Access Compliance Report

Public Rights-of-Way

(Curb Ramps)

Intersection ID: 11775	Main Street: E_18TH_ST	Cross Street: SEIGLE_AV	Location: S
ADA ID: 2C873846FEAB	Ramp Type: Perp	Initial Pass/Fail: Fail	Overall Compliance: No
		Severity Score: 8.75

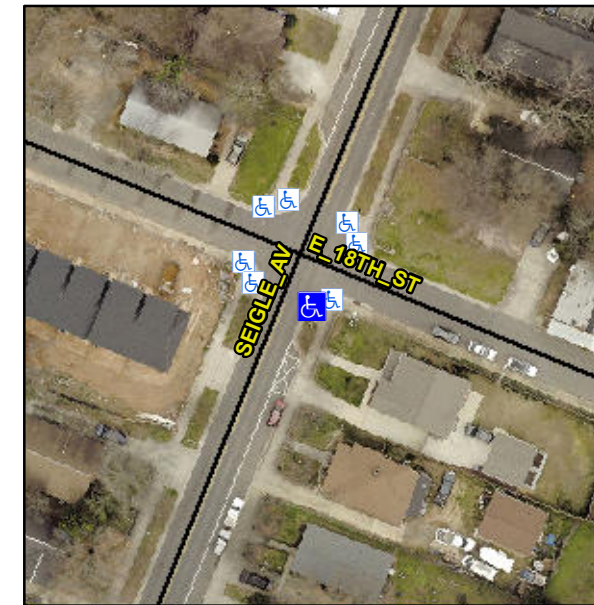
Not Found, R304.5.1

Compliance	Description	Data	Compliance	Description	Data
N/A	Ramp Length (in)	60.0	Yes	Ramp Slope (%)	6.2
No	Ramp Width (in)	47.5	Yes	Ramp XSlope (%)	0.8
N/A	Flare Type LT	N/A	N/A	Flare Type RT	N/A
N/A	Flare Slope LT (%)	N/A	N/A	Flare Slope RT (%)	N/A
N/A	Flare Traversable LT?	N/A	N/A	Flare Traversable RT?	N/A
N/A	Landing Length (in)	N/A	N/A	DWS Provided?	N/A
N/A	Landing Width (in)	N/A	N/A	DWS Contrast?	N/A
N/A	Landing Slope (%)	N/A	N/A	DWS Length (in)	N/A
N/A	Landing X Slope (%)	N/A	N/A	DWS Full Width?	N/A
N/A	Landing Curb? (Y/N)	N/A	N/A	DWS Offset (in)	N/A
N/A	Shared Landing?	N/A			
N/A	Gutter Ponding?	N/A	N/A	Gutter Slope (%)	N/A
N/A	Gutter Lip Ht (in)	0.5	N/A	Gutter X Slope (%)	N/A
N/A	Painted X Walk1?	No	N/A	Painted X Walk2?	N/A
	X Walk 1 Direction	To NW		X Walk 2 Direction	N/A
N/A	X Walk 1 Width (in)	N/A	N/A	X Walk 2 Width (in)	N/A
	X Walk 1 Slope (%)	2.5		X Walk 2 Slope (%)	N/A
	X Walk 1 X Slope (%)	0.7		X Walk 2 X Slope (%)	N/A

Remove & Replace Entire Ramp.
